# MERCUISER SERVICE BULLETIN

Section: XII (Service  
Bulletins)  
Number: 15  
Date : 4/29/64

### E. FUEL RETURN LINE FOR MERCUISER "110" AND "120" ENGINES

Figure 7. "T" Facing Down (Incorrect)

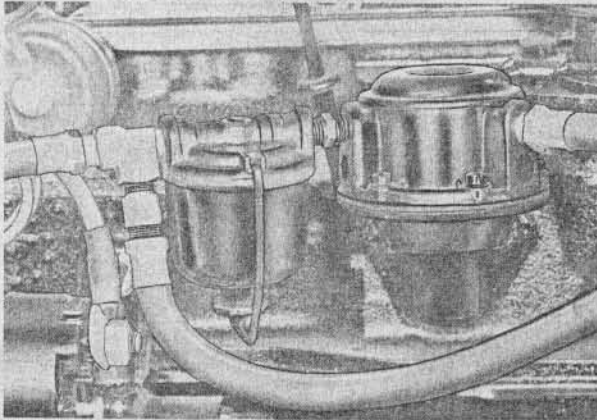
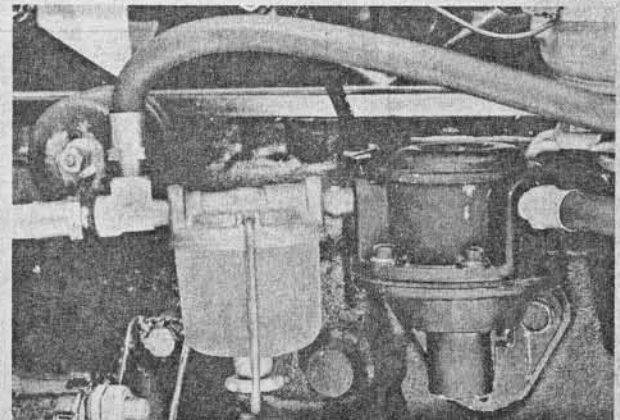
To aid in servicing the fuel filter on MerCruiser "110" and "120" Marine Engines, the fuel return line "T", previously installed with the "T" facing down (Figure 7), should be installed with the "T" facing up. (Figure 8)

Check and change on the MerCruiser Marine Engines which you service.
